TVGA
Engineering, Surveying, P.C.

NO EXCEPTIONS TAKEN REJECTED
 FURNISH AS CORRECTED REVISE AND RESUBMIT

2 ~ x11w
DRIP PL

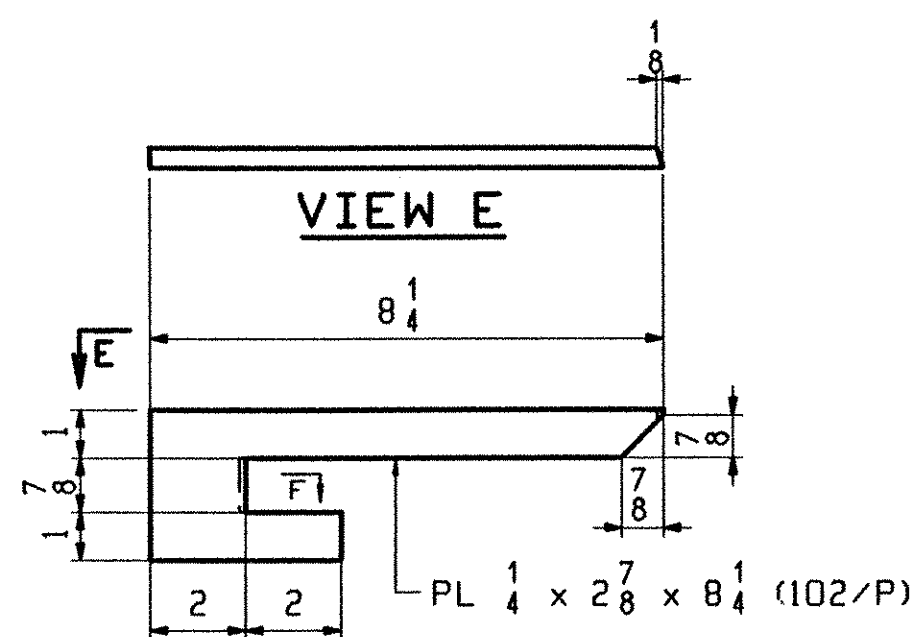
ENGR VERIFY WIDTH OF PL REDUCED TO CLEAR "K" OF W33 THICKNESS INCREASED TO 1/4" TO MAINTAIN NET SECTION
